**Responses to Comments on  
Landscape and Visual Impact Assessment Report for S16 Planning Application  
( Intensification Scheme) (Issue 2)**

1. Chief Town Planner/Urban Design and Landscape, Planning Department [from Mr. Jeff LEUNG via email dated 24 May 2022]

**Figure 3.2.j Photomontage of Visually Sensitive Receiver VP9 Public Users near Chung Uk Tsuen Light Rail Transit Station**

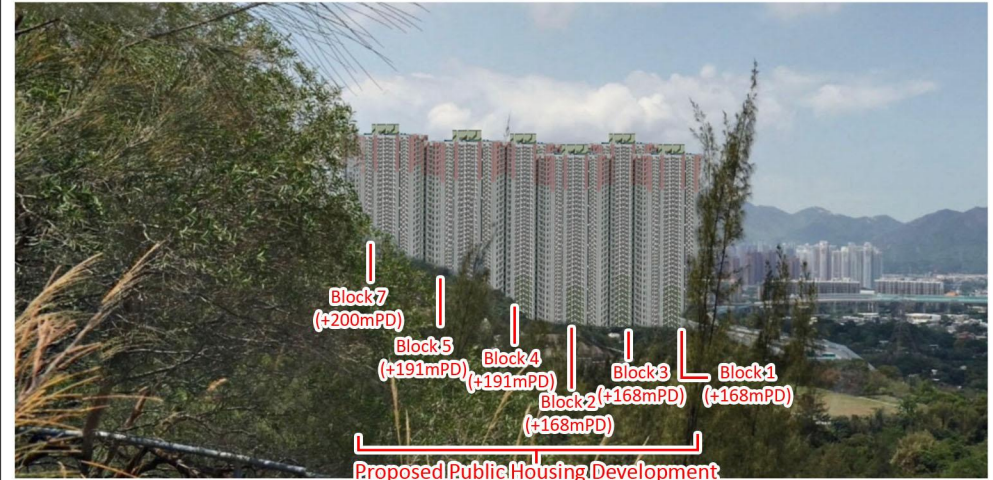
Comments	Responses
<p>impacts between the two schemes for VP1 as “<b>slightly adverse</b>” with reference to the relevant photomontages (Figure 3.2.a refers).</p> <p>b. <b>VPs 10 &amp; 11</b> – With reference to the relevant <b>photomontages</b> (Figures 3.2.j &amp; 3.2.k [<i>missing in this FI submission</i>] refer), the proposed scheme will cause <b>noticeable additional blockage of open sky</b> comparing to the baseline scheme. In view of the above, the statement that “the unmitigated visual impact... is expected to have <b>no major difference</b> between two schemes” seems to be not justified (Paras. 3.7.15 &amp; 3.7.17 refer). In view of the above, please consider rating the additional visual impacts between the two schemes for VPs 10 &amp; 11 as “<b>moderately adverse</b>”.</p> <p>10. <b>Photomontages</b> – Inaccuracies are still found in photomontages at VP9 (Figure 3.2i). The residential blocks in the proposed scheme <b>shall appear higher</b> which would cause more additional blockage of open sky view at this VP. Also, the photomontages at VP11 are missing in this VIA (i.e. Figure 3.2k). Please supplement.</p>	<p>10. Noted and VP9 is revised accordingly.</p>
